35/13-06T 22 Hesketh St 35/13-09C
Chevy Chase Village Historic District, 35/13

CASE NO. A-5517
Appeal of John J. Campanella and Kathleen M. Campanella
(Hearing held April 6, 2009)

DECISION OF THE BOARD OF MANAGERS

From: Fothergill, Anne
Sent: Wednesday, February 22, 2012 4:47 PM
To: 'Josh Mohr'
Cc: Anne Decker
Subject: RE: New project at 22 Hesketh Street

2nd Floor Plan

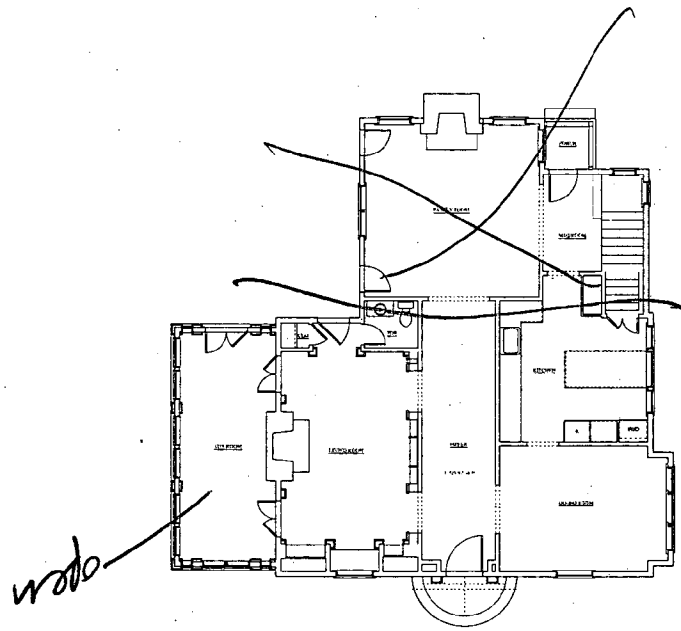
Can you show me on a plan what is the original block, what was built in 2000, and what additions are being proposed now. My concern is the overall impact to the historic house and how much will remain visible and readable with new two-story additions. The HPC will not want the original form enveloped in additions, and I am worried that is what is happening. The applicants are approved for a one-story addition and can build that without further review (a HAWP does not expire).

Proposed:
2nd story addition over sunporch
Two-story rear addition.

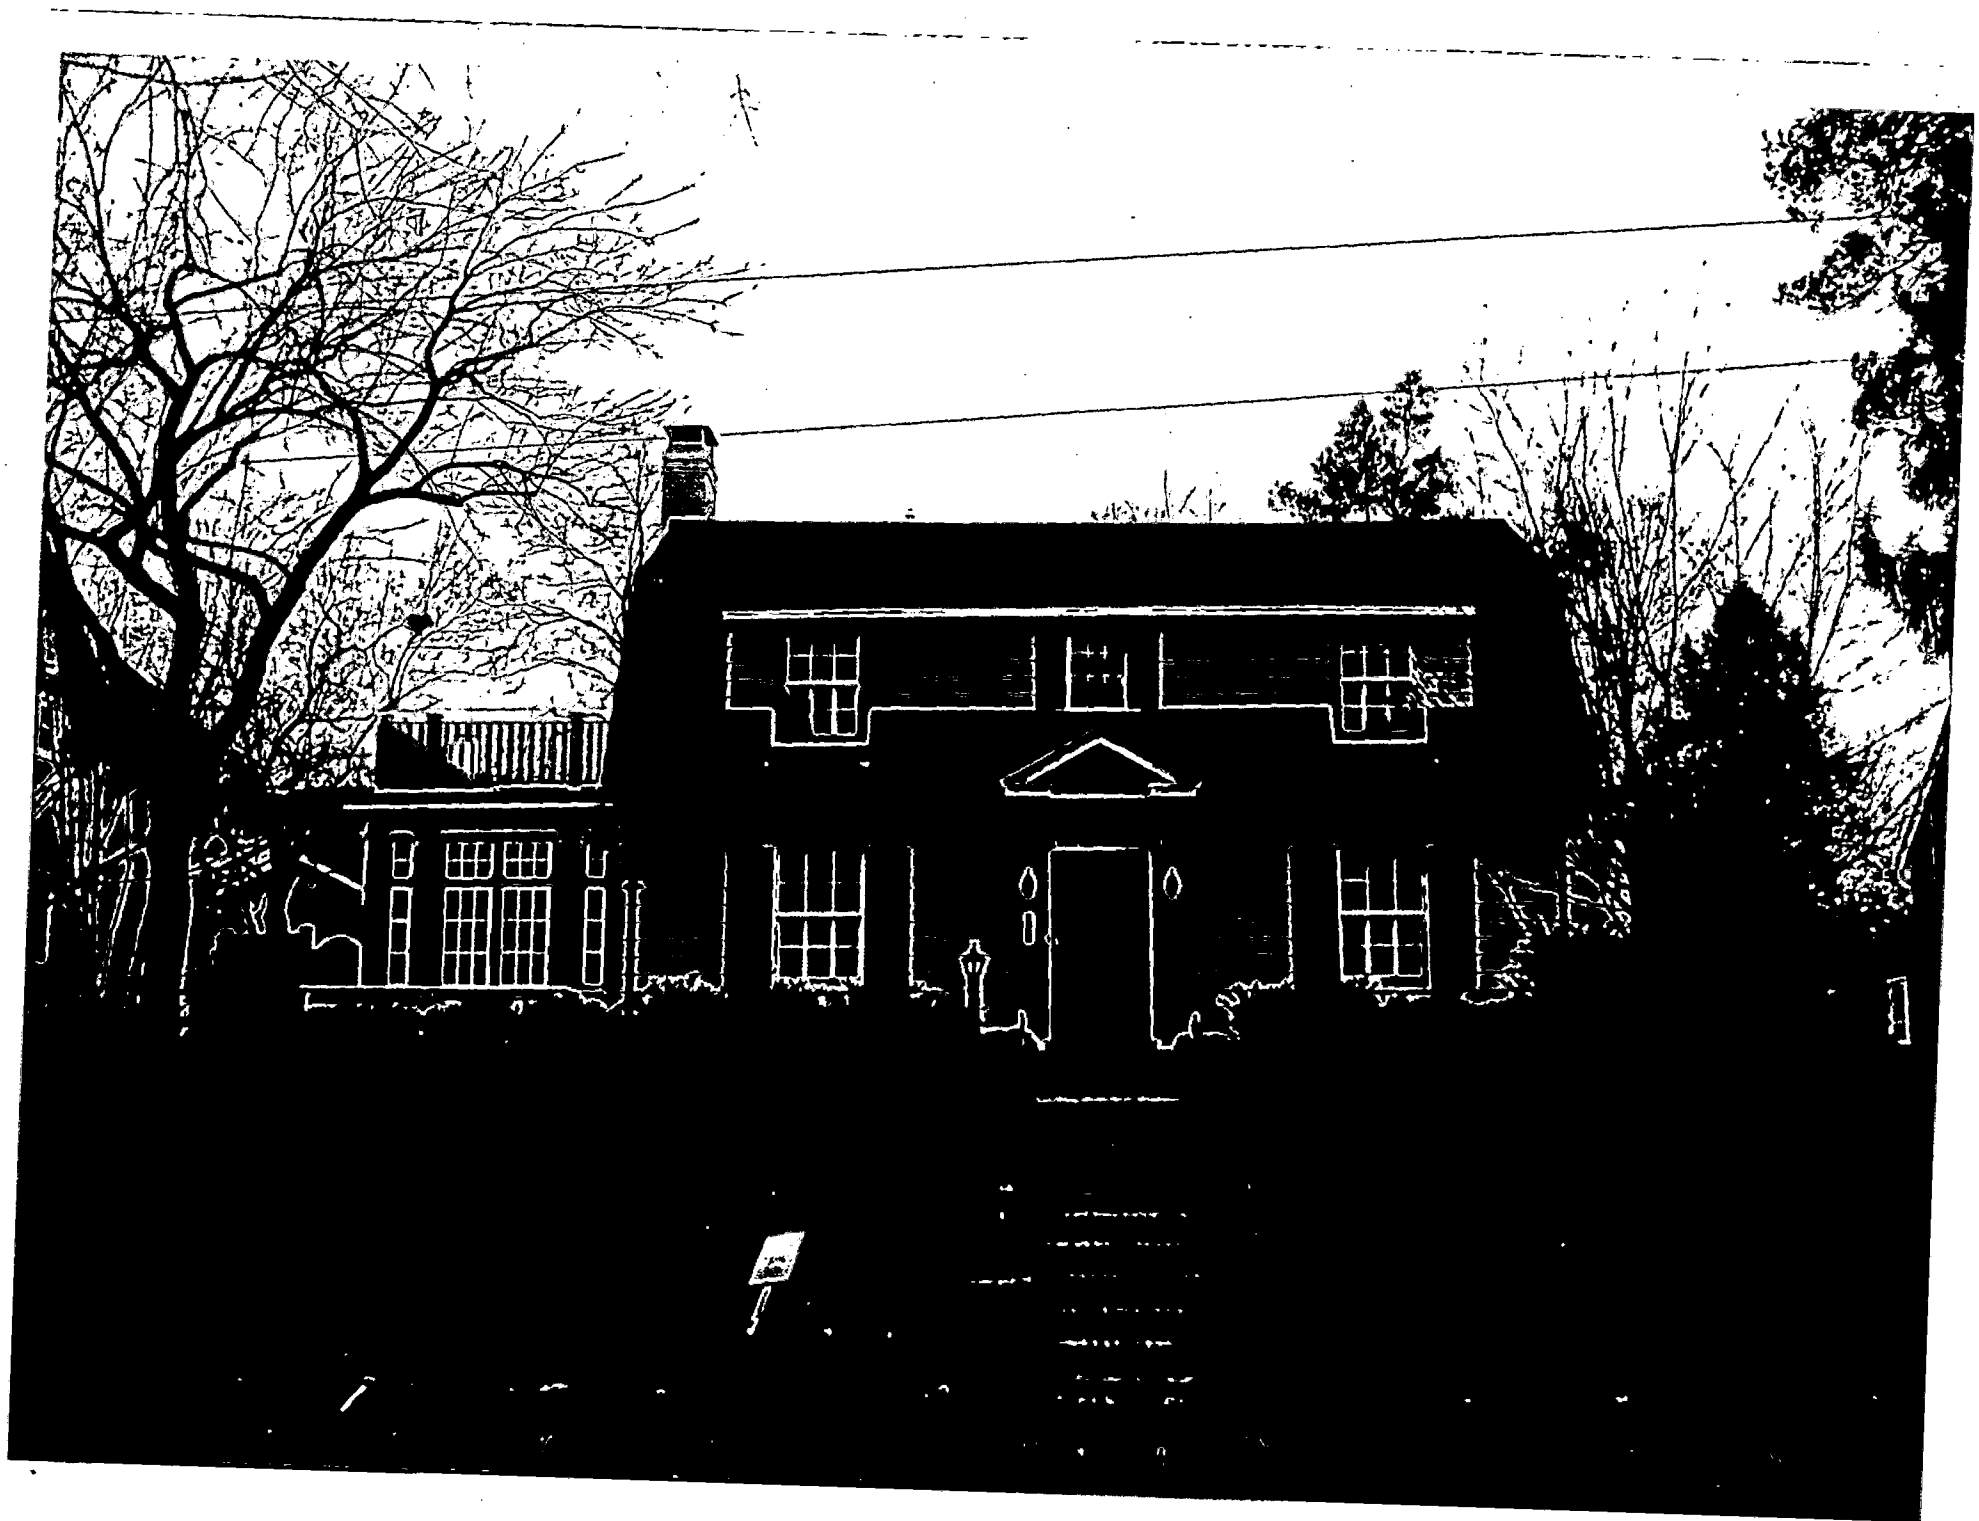
Any thoughts on whether or not something similar to this might be acceptable?

Generally preservation review criteria don't support side additions but the CCV guidelines do say:

"second or third story additions or expansions which do not exceed the footprint of the first story should be subject to moderate scrutiny..." and moderate scrutiny states that in addition to "issues of massing, scale and compatibility, preserving the integrity of the resource is taken into account" and also discuss the use of compatible materials and compatible design.

I would need to see your design to evaluate the proposed side addition's compatibility and massing and scale and whether you are impacting the integrity of the historic block of the house. If you are doing a rear 2nd floor addition in addition to the side addition, I would discourage you from enveloping the historic house in new additions and to be sensitive to that in your design. I think your idea of setting it back from the original front plane is a good idea so much of that original front left corner will remain visible. Also, the new roof line should be lower so that original gambrel roof line is still visible. If you have a schematic design, I would be happy to take a look at it.
